Table of Contents

Departmental Comments	Responses to Comments
1.	Comments from Environmental Protection Department	
1.1	Please submit dedicated reports for the sewerage review. <u>Planning Statement</u>	Noted. A Sewerage Impact Assessment (SIA) is attached under Appendix A for comments. Relevant paragraphs in the Planning Statement have been updated as well, please refer to Appendix F .

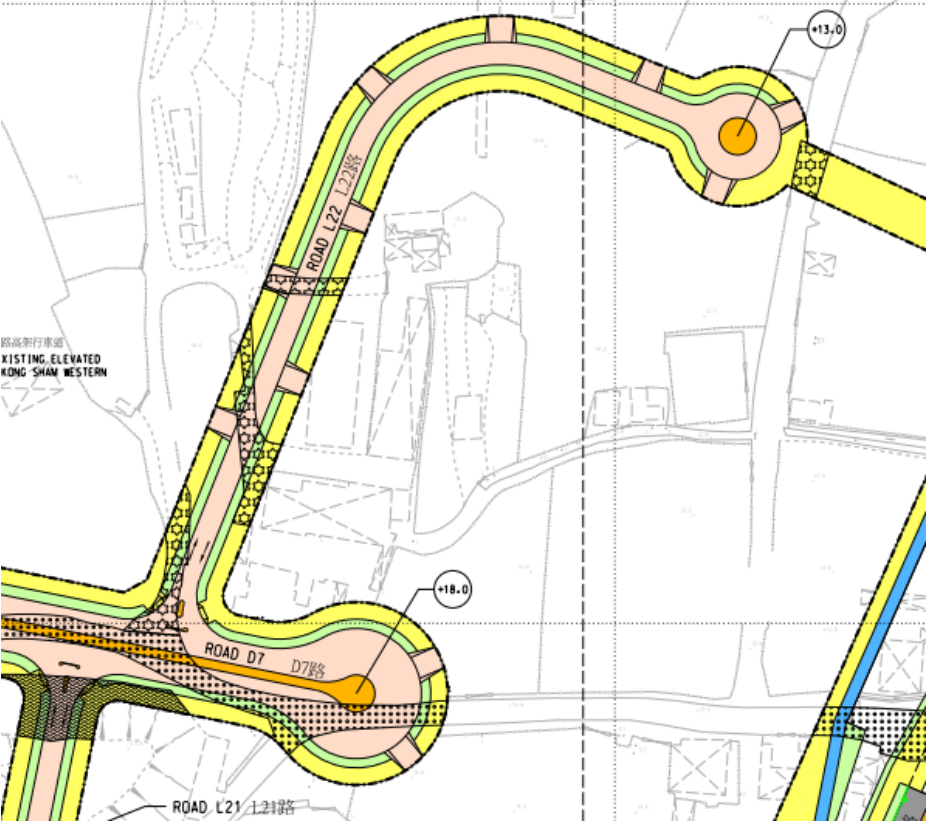
1.5	Section 2.1.1: The potential air quality impacts arising from the construction activities associated with the proposed development (on the surrounding environment) should also be evaluated. Please provide the following information if available: the size of the site formation or excavation area, the volume of excavated materials to be managed, the maximum number of construction trucks and mechanical equipment to be deployed at the work site at any given time, the identification of nearby ASRs along with their separation distances from the project site boundary, the identification of any	The construction phase impact has been added as Section 2.10 of the revised Environmental Review. Please see Appendix G for consideration.
